KS-20255 TELEPHONE KIOSK (DIAMOND KIOSK) IDENTIFICATION, INSTALLATION, AND MAINTENANCE

1.001 This addendum supplements Section 508-355-100, Issue 2.

1.002 This addendum is issued to:

Fig. 16—Wiring Diagram of Telephone Kiosk

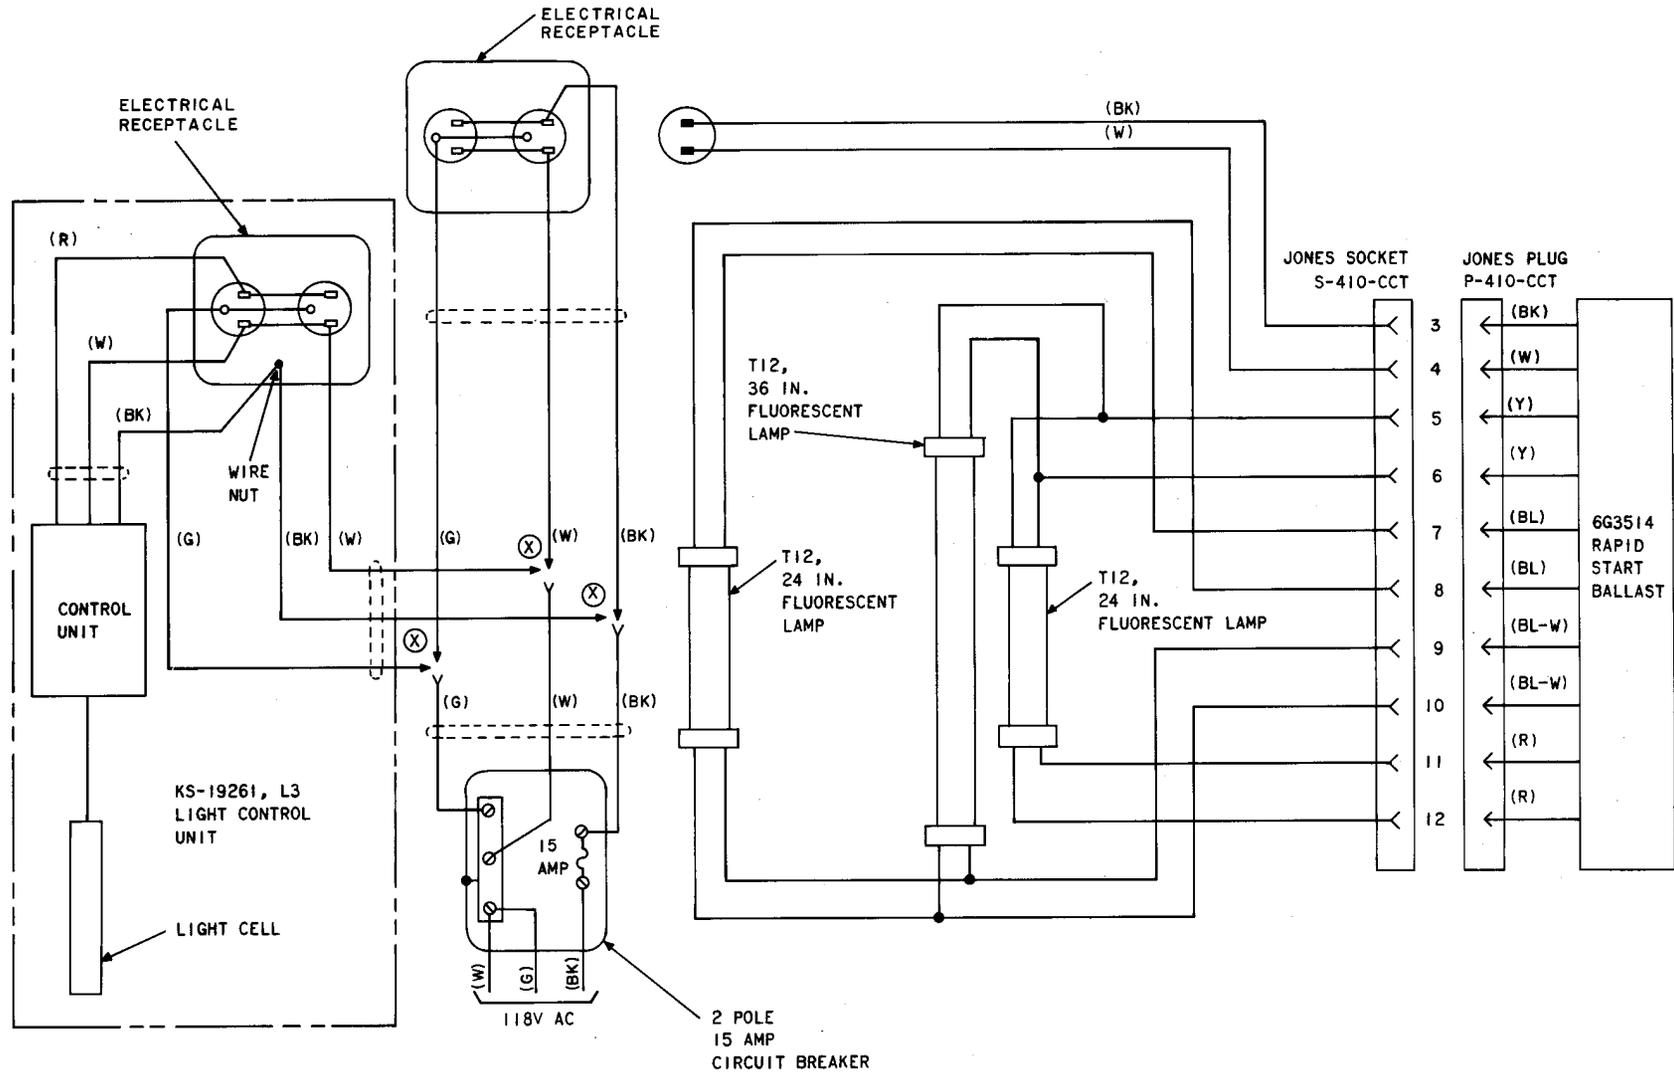
- Revise Fig. 16 to change wiring at the circuit breaker
- Revise Table A to change Part No. of light control.

- (a) Fig. 16, revised

⊗ OPTIONAL WIRING FOR KS-19261, L3 LIGHT CONTROL UNIT.
